# Addressing measurement requirements for EVM

**2021.04.29**

*Affiliated with Keysight Technologies*

- Motivation: Close the TBD status of Error Vector Magnitude in clause 156
- This presentation is in support of a comment against draft 1.0

### 156.9.9 Error vector magnitude

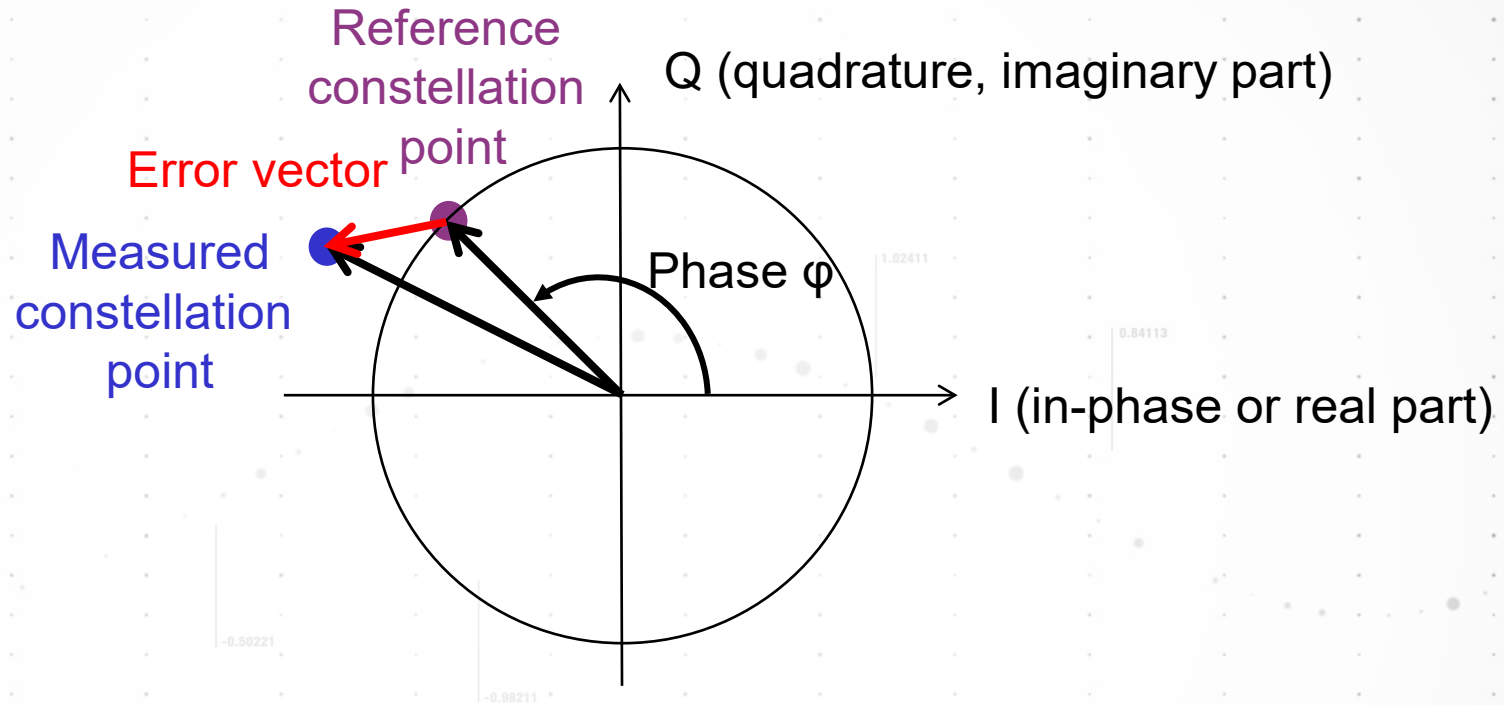
First name	Surname	Affiliation				
Greg	Le Cheminant	Keysight Technologies				
Click on column headers for help						
Category	Page	Sub-clause	Line #	Comment	Proposed Change	Must Be Satisfied
Technical	76	156.9.9	31	<p>The definition of error-vector-magnitude (EVM) is currently in TBD status. EVM requires a definition as well as a specification limit. Small changes in EVM can be seen as large changes in OSNR (see <a href="http://grouper.ieee.org/groups/802/3/cn/public/adhoc/18_1025/anslow_3cn_01_181025.pdf">http://grouper.ieee.org/groups/802/3/cn/public/adhoc/18_1025/anslow_3cn_01_181025.pdf</a>). A specification limit requires a known method of measurement. The complexity of the EVM measurement requires a specific analysis process to achieve consistent results. This process should be explicitly defined. See <a href="https://grouper.ieee.org/groups/802/3/cn/public/adhoc/19_0207/lecheminant_3cn_01_190207.pdf">https://grouper.ieee.org/groups/802/3/cn/public/adhoc/19_0207/lecheminant_3cn_01_190207.pdf</a> and <a href="https://grouper.ieee.org/groups/802/3/cn/public/adhoc/19_0509/lecheminant_3ct_01_190509.pdf">https://grouper.ieee.org/groups/802/3/cn/public/adhoc/19_0509/lecheminant_3ct_01_190509.pdf</a></p>	<p>A method for computing EVM has been developed by Keysight Technologies and used in ITU and OIF standards. This is contained within a large Matlab script. The computation details need to be followed exactly to achieve consistent results. This script is available for use within the IEEE 802.3 standard. It is likely too large to be directly written into the standard document, so If used, guidance from the group is requested on the details for script management and inclusion within the 802.3cw clauses. A presentation on the Keysight EVM script is planned to support this comment</p>

The error vector magnitude, as defined in TBD, shall be within the limits given in Table 156-6.

- Update 156.9.9 to include a reference to the OIF 400ZR document
  - [https://www.oiforum.com/wp-content/uploads/OIF-400ZR-01.0\\_reduced2.pdf](https://www.oiforum.com/wp-content/uploads/OIF-400ZR-01.0_reduced2.pdf) (Appendix C 20.1 through 20.4).
  - OIF also has a Password protected Matlab script that executes the EVM mathematics.
- ITU: Currently an EVM script (along with example data and corresponding results) is used but accessible only for members
- 
- What makes sense for 802.3cw?
